Service Bulletin

Object: **Cable relocation key switch ZADI**

Product: **F4 RC 2015**
ZCGMCFTW0FV005906
ZCGMCFTW1FV006272

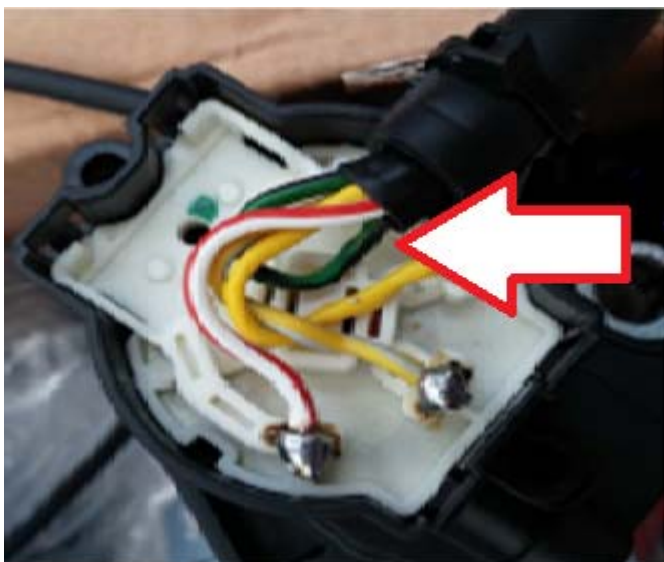
DESCRIPTION OF THE DEFECT:

As the picture in attached.

On motorcycles involved in this service bulletin, the green/black wire in some cases is too stretched. This problem in addition to the vibrations and twists due to movement of the steering, may result in loosening or detachment of the contact in the ignition switch.

- Remove the key switch from the bike, respecting the removal instructions given in the workshop manual.
- In the fixing area of the wires to the main switch, free the black sheath that covers the wires by any obstacles and closure, in order to leave the cables free to slide.
- Pull gently a bit out the wire green/black from the sheath, in order to leave some free play, as illustrated in the image below.
